Applicable Vehicles					
Model(s)	Year	Eng. Code	Trans. Code	VIN Range From	VIN Range To
Jetta	2020 – 2021	1.4T (DGXA, DJXA)	All	All	All

Revision Table			
Instance Number	Published Date	Version Number	Reason for Update
2072378/2	5/02/25	01-23-12	Included FTIV replacement instructions.
2072378/1	12/11/23	01-23-12	Original publication.

Technical Background

Figure 1.

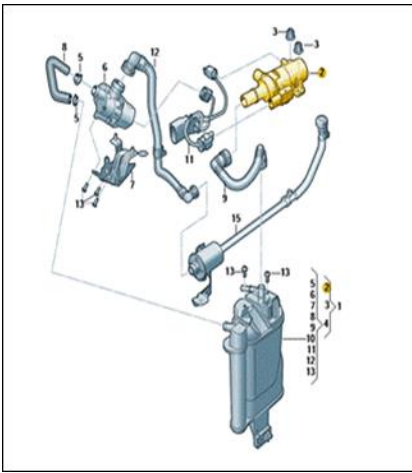
In addition to the software update detailed below, there is an improvement to the FTIV (fuel tank isolation valve / tank switch-off valve -**N288-**) (Figure 1.), which is necessary in preventing erroneous occurrences of the P2421 fault code.

The FTIV / tank switch-off valve -**N288-** currently installed on the vehicle must be inspected, to verify whether an improved part has already been installed. The FTIV / tank switch-off valve -**N288-** is mounted to the EVAP canister assembly, as shown below.

Remove the EVAP canister assembly and inspect the face of the FTIV / tank switch-off valve -N288-. If the part is already updated, it will be part number 5Q0.201.549.C. Alternatively, it may have a white paint marking or an "02S" printed after the part number, as shown in Figure 2.

- If the part number is 5Q0.201.549.C, the FTIV / tank switch-off valve -N288- is already the updated component. In this case, DO NOT replace it, and instead reinstall the EVAP canister assembly. Only the software update will be required.
- If the part has a white paint mark or "02S", the FTIV / tank switch-off valve -N288- is already the updated component. In this case, DO NOT replace it, and instead reinstall the EVAP canister assembly. Only the software update will be required.
- If the part number is not 5Q0.201.549.C, there is no white paint mark, and "02S" is not included on the FTIV / tank switch-off valve -N288-, the component must also be replaced in addition to the software update. Always refer to ETKA for the most up to date part number information.
